**CHANGE
NO.1**

MODIFICATION WORK ORDER

MWO 9-2320-280-20-1

MODIFICATION OF 1-1/4 TON VEHICLES

FIGURE 1

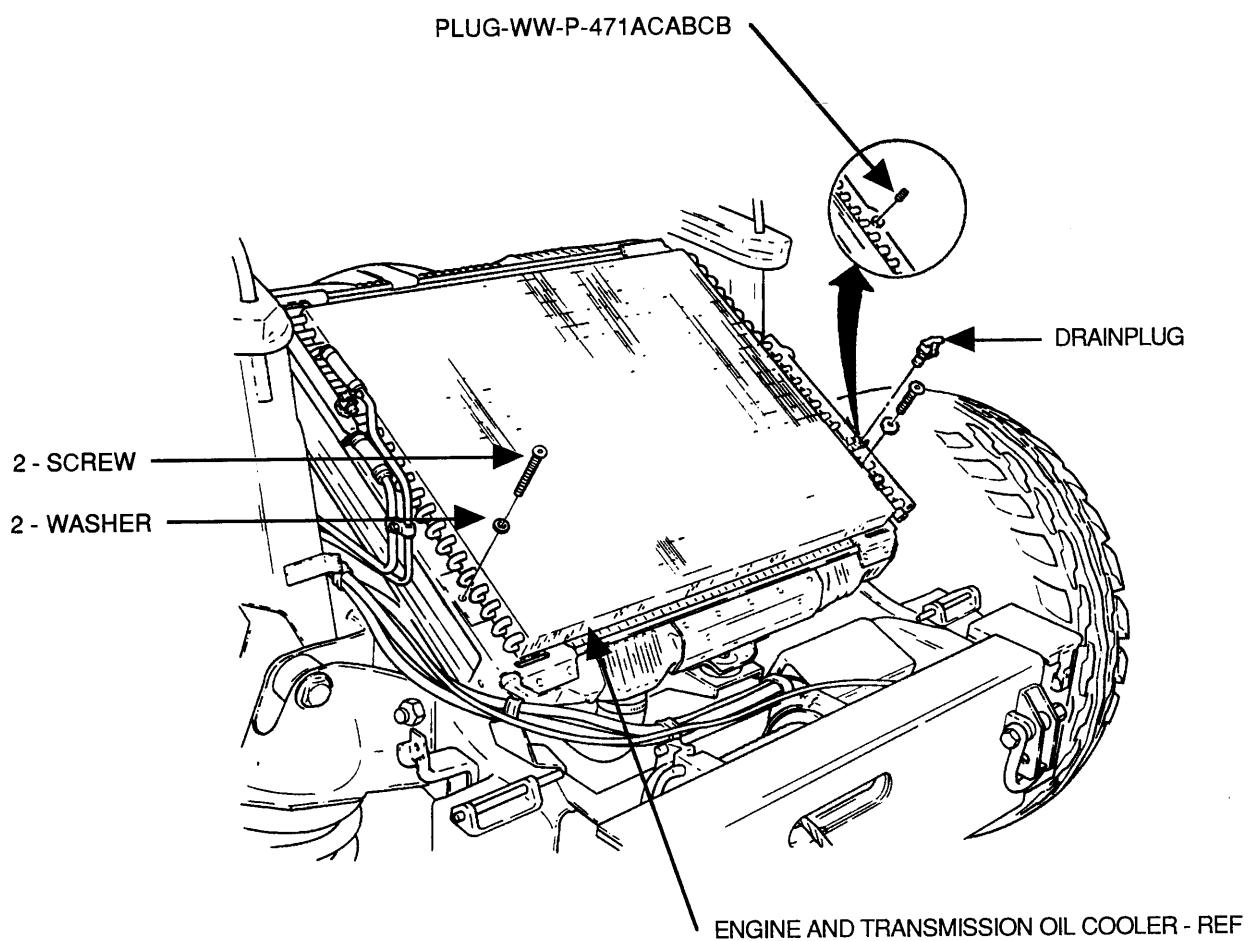
- (1) Disconnect battery ground cable. (Refer to TM 9-2320-280-20.)
- (2) Remove hood. (Refer to TM 9-2320-280-20.)
- (3) Remove left side splash shield. (Refer to TM 9-2320-280-20.)
- (4) Remove drainplug from oil cooler as shown in figure 1.

- (5) Install WW-P-471ACABCB plug in oil cooler as shown in figure 1.
- (6) Remove two lower screws and washers from oil cooler as shown in figure 1.
- (7) Remove two nuts, washers, screws, and clamps from power steering hoses as shown in figure 2.
Save for installation.
- (8) Remove two clamps and hose from control valve elbow and steering gear as shown in figure 2.
Save for installation.

FIGURE 3

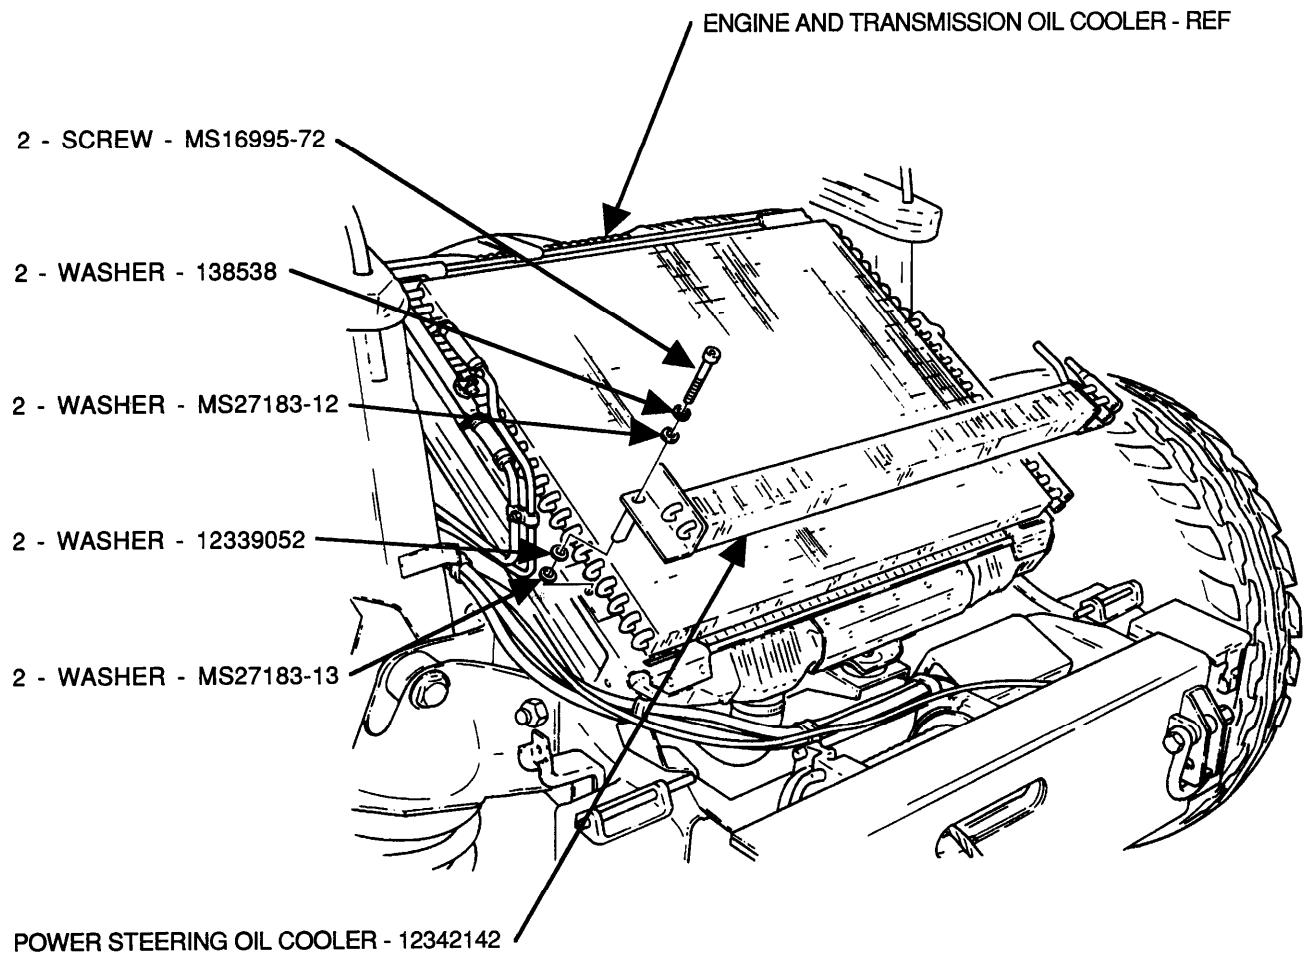
- (1) Position two MS16995-72 screws, 138538 washers, and MS27183-12 washers to 12342142 power steering oil cooler as shown in figure 3.
- (2) Position two 12339052 washers and MS27183-13 washers to oil cooler as shown in figure 3.
- (3) Install power steering oil cooler to oil cooler and secure with two screws as shown in figure 3. Tighten screws to 12-14 lb-ft (14-18 N m).
- (4) Install 12338330-6 hose to power steering oil cooler and power steering gear and secure with 12339884-1 clamp and existing clamp as shown in figure 4.
- (5) Install 12338330-7 hose to power steering oil cooler and control valve elbow and secure with 12339884-1 clamp and existing clamp as shown in figure 4.
- (6) Position two existing clamps on hose and secure with two screws, washers, and nuts as shown in figure 4.
- (7) Secure hoses with MS3367-3-0 tiedown as shown in figure 4.
